From: Watkins, Robert
Sent: Wednesday, November 20, 2019 11:56 AM
To: dmacnelly@architecturefirm.co
Cc: Werner, Jeffrey B
Subject: November BAR Action - 421 West Main Street

BAR 18-02-05
421 West Main Street
Tax Parcel 320178000
Ed Brown, Owner/Danny MacNelly (ARCHITECTUREFIRM), Applicant
Revisions to Site Plan

**CITY OF CHARLOTTESVILLE
BOARD OF ARCHITECTURAL REVIEW
STAFF REPORT
November 19, 2019**

Revisions to Site Plan/Landscape plan for 421 West Main

SITE ELEVATION A - FACING EAST

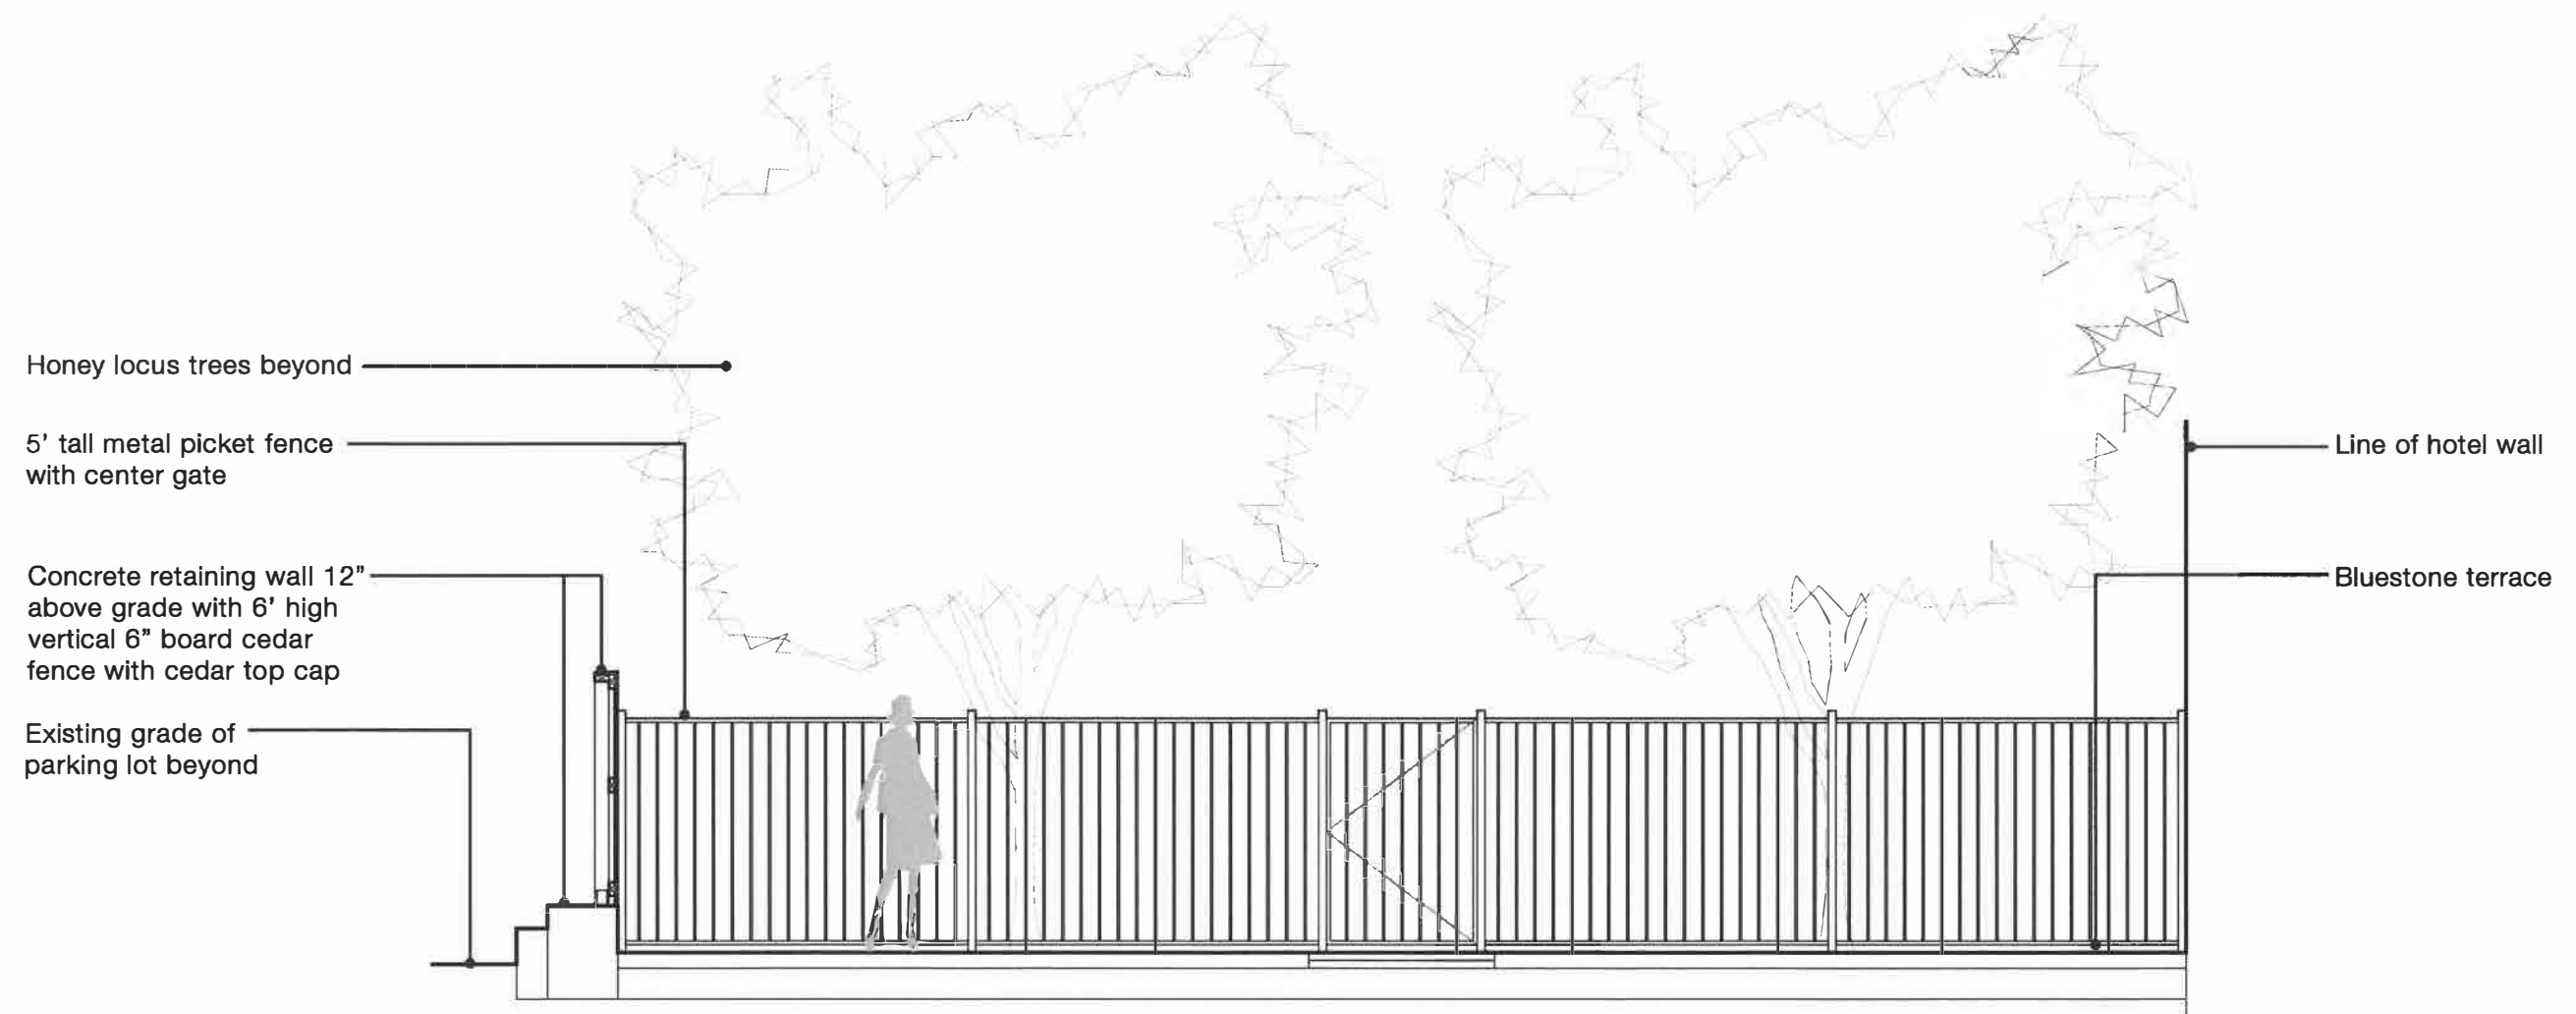
- **That the top of the fence adjacent to the CenturyLink Building be no more than 6' above grade at the CenturyLink side**
- **That the in-ground lighting that is not underneath trees should be aim-able and not shine directly into the sky**

- The fence height should be a maximum of 6 feet above proposed grade (see pages 3 and 4)
- The fence should terminate at the proposed gate facing West Main Street (see pages 3 and 4)
